issued for:
NON MATERIAL VARIATION

project no.	drawing no.	revision
21.43	L(2-)-02	E

project / client:
Kelly Hensler
 15 Hillmoss
 Kilmaurs
 KA3 2RS

drawing:	scale:
Rear elevation and cross section as proposed	1:50@A3
drawn by:	date:
PE	12.11.21
checked by:	date:
-	-

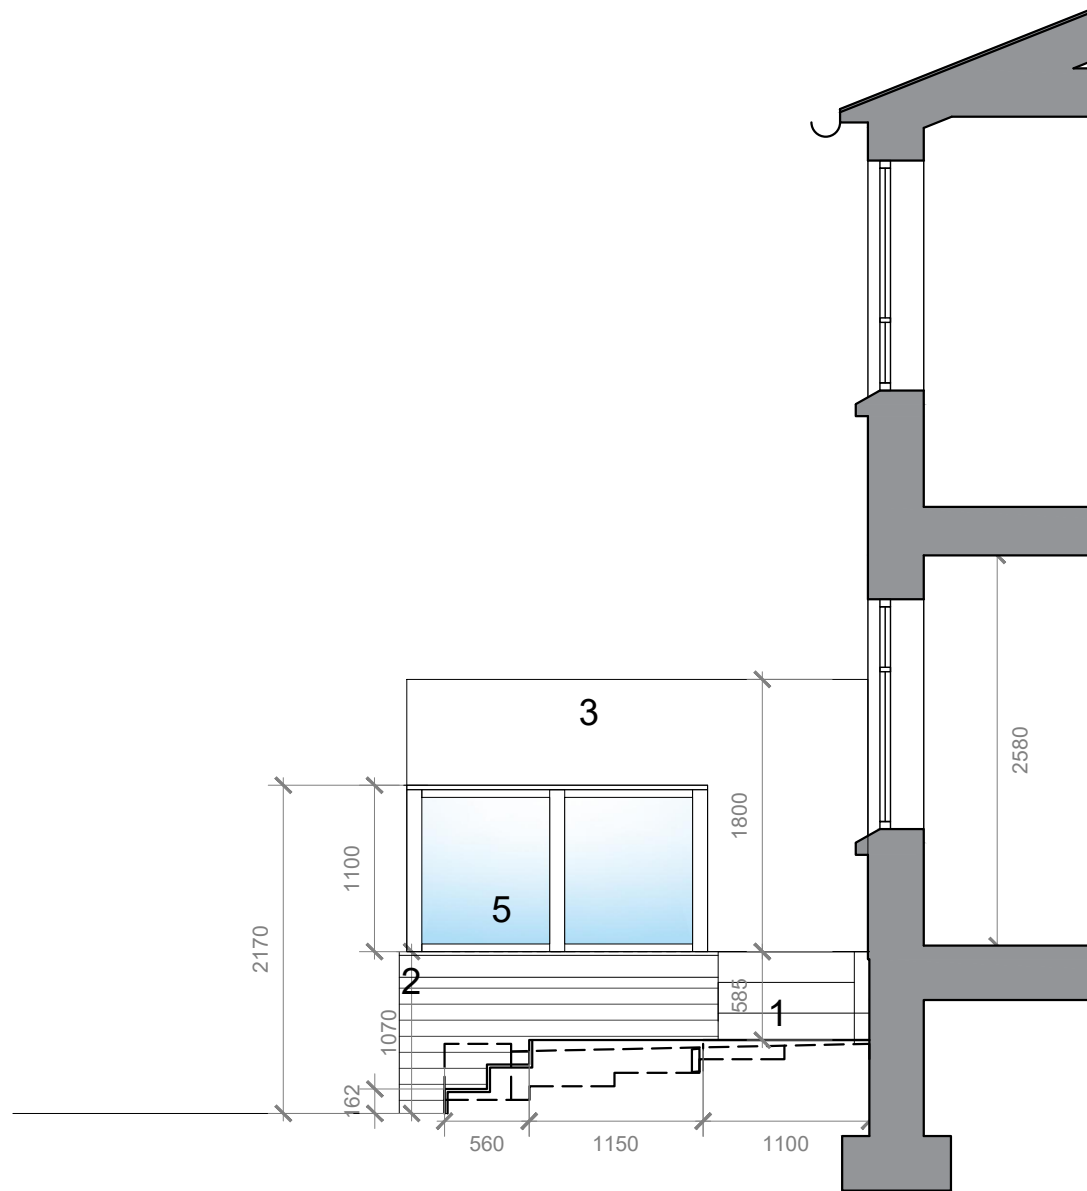
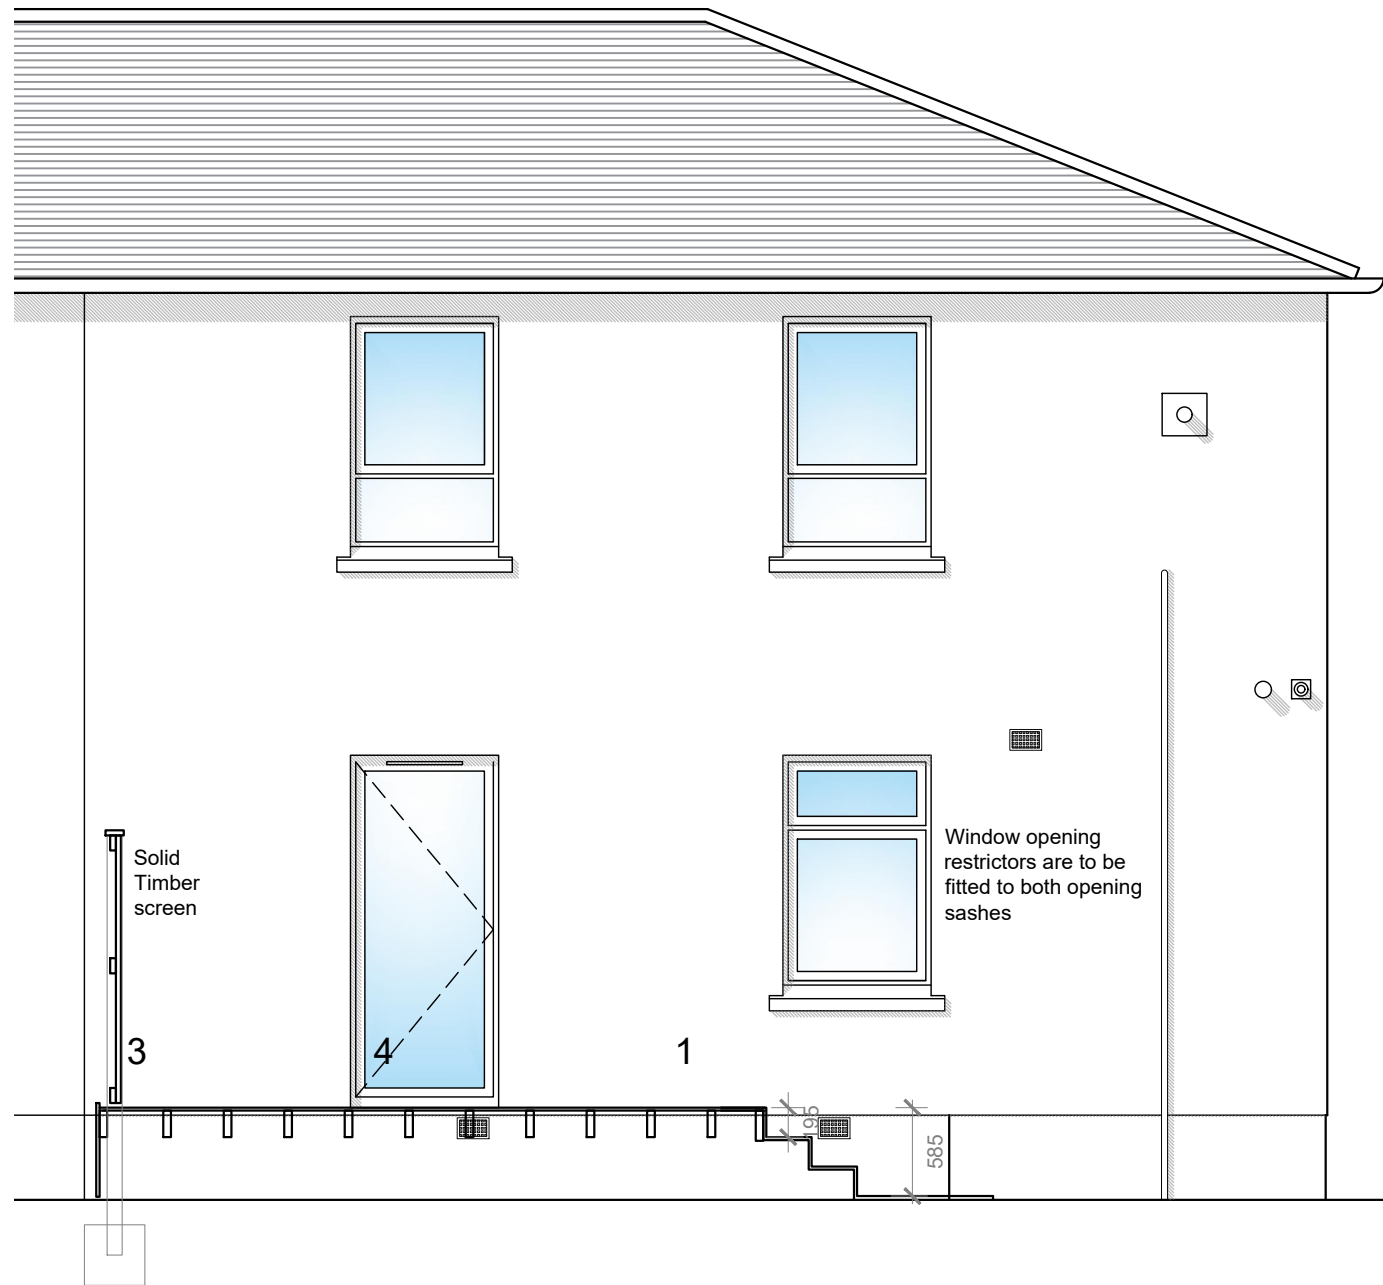
E	01.11.23	Barriers amended. Bench removed.	PE	-
D	13.04.22	Provision of window opening restrictors, and trickle ventilator noted. Protective barriers adjusted.	IB	-
C	30.03.22	Decking options added.	IB	-
B	28.03.22	Height of screen fence revised.	IB	-
A	20.12.21	Deck amended.	IB	-
